ANN ARBOR HISTORIC DISTRICT COMMISSION

Staff Report

ADDRESS: 616 West Madison Street, Application Number HDC12-193

REPORT DATE: November 5, 2012

BASEMENT PLAN
SCALE: 1/8" = 1'-0"

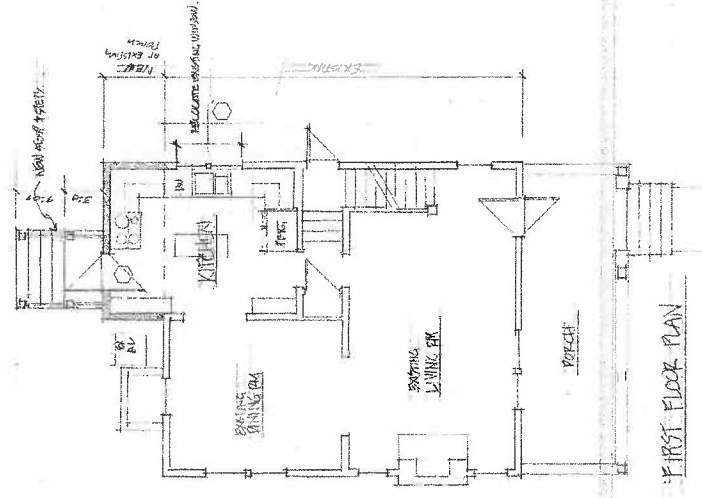
1. The submitted plans show the replacement of the existing east, north and west CMU basement foundation walls with new 8" CMU blocks, which will then be painted to match the existing foundation. Staff already approved the replacement of these walls at the time the HDC application was submitted because a portion of the east wall had already collapsed, and the owner needed to retain a contractor as quickly as possible. A photo submitted with the application shows the collapsed portion of the foundation wall from the basement interior.

3. The north elevation (rear wall) basement window is proposed to be converted to an egress window. The new window will measure two feet six inches wide by three feet tall. A new window well will also be constructed that measures one foot six inches deep, and three feet by three feet across. It will be constructed of six inch by six inch pressure treated wood. Relocating the egress window to the rear of the house from the east side will result in about the same level of visibility from the sidewalk since this is a corner lot. It is generally desirable to get an egress window out of the driveway, however, because of potential conflicts with cars (blocking or driving into it).

4. The new foundation wall is also proposed to be expanded beneath the existing rear porch. This will allow the rear porch to be converted into living space, and accommodate an expansion of the kitchen. The foundation wall will extend beneath the west and north walls of the rear porch, and continue the east foundation wall of the house to allow for an expansion of the porch.

FIRST FLOOR PLAN

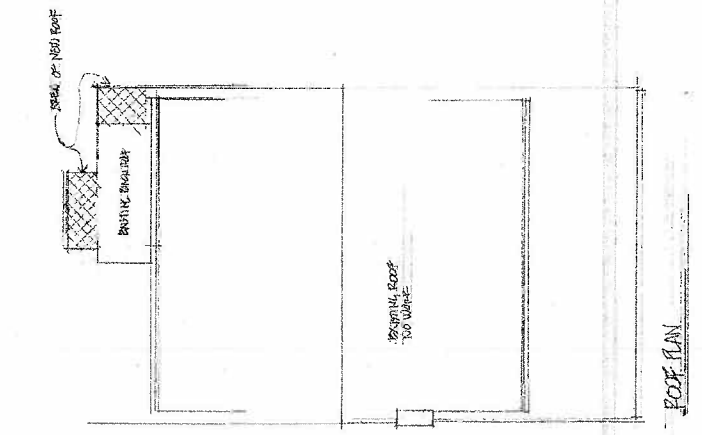
5. To expand the kitchen, the applicant also proposes expanding the porch two feet and six inches to the east, so that it is aligned with the east wall of the house. The existing porch does not appear to be original to the house. The east, north, and west walls of the porch will then be enclosed by removing the existing partial walls and constructing new walls. The porch currently has four one-over-one windows and a door. Based on the provided photographs, the windows and door appear to be aluminum. The proposed walls will have no windows, and one door will be located in the north elevation of the porch. The siding will be painted sawn wood shingles to match the existing rear wall, and the original rear kitchen door will be relocated to the new north wall of the porch.

7. Because of the expansion and remodeling of the kitchen, the applicant proposes relocating two windows in the east elevation to accommodate the interior kitchen. The two windows, which are located towards the rear of the house, are proposed to be moved approximately one foot towards the north (rear). The two windows feature four-over-one sashes that are a character-defining feature that is typical of the Craftsman style and are likely original to the house. Staff feels that since the windows would be retained, relocating them twelve inches would not diminish the character of the existing historic resource.

NORTH ELEVATION

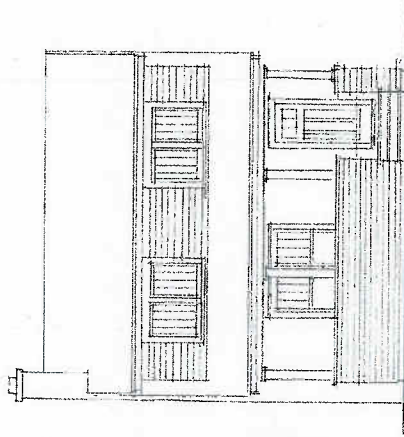
6. A new wooden stoop and set of wooden stairs is proposed to be built at the rear of the new kitchen expansion to provide access to the rear yard. It will have simple square balusters and a simple square railing, and is an appropriate design.

EAST ELEVATION

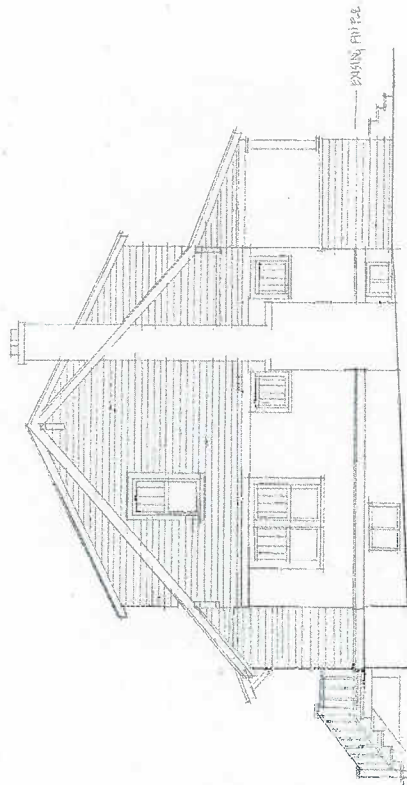
2. The applicant also proposes replacing two windows in the east elevation of the foundation wall and two windows in the west elevation of the foundation wall when the foundation is replaced. The proposed windows are wood awning windows, and would match the existing windows, with one exception -- the basement window on the east elevation (along the driveway) closest to the rear of the house is a larger egress window. That window opening would be reduced in size to match the other existing window opening in this elevation.

8. The applicant proposes removing a non-original concrete retaining wall that is located along the east lot line. It is proposed to be replaced with a new precast concrete retaining block wall. The existing driveway along the east lot line will also be removed, and replaced with a new driveway of asphalt, compacted gravel, or concrete.
